Sundry Print Report

Well Name: MUSTANG 8-17 FED COM

Sundry ID: 2800590

Type of Action: APD Change

WELL LOCATION AND ACREAGE DEDICATION PLAT

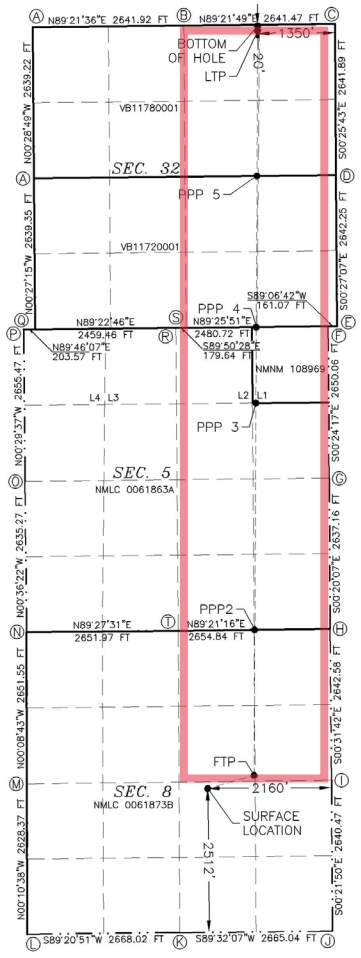
API: 30-025-53001
Permitted BHL: SWSE, 20 FSL, 1870 FEL, 17-25S-32E
Proposed BHL: NWNE, 20 FNL, 1350 FEL, 32-24S-32E
Permitted Well name: MUSTANG 8-17 FED COM 627H
Proposed Well name: CHINCOTEAGUE 8-32 FED STATE COM 627H
Permitted TVD/MD: 11973/19548
Proposed TVD/MD: 11027/23927

UL or lot no.	Section	Township	Range	Lot Idn	Feet from the	North/South line	Feet from the	East/West line	County
B	32	24 S	32 E		20	NORTH	1350	EAST	LEA
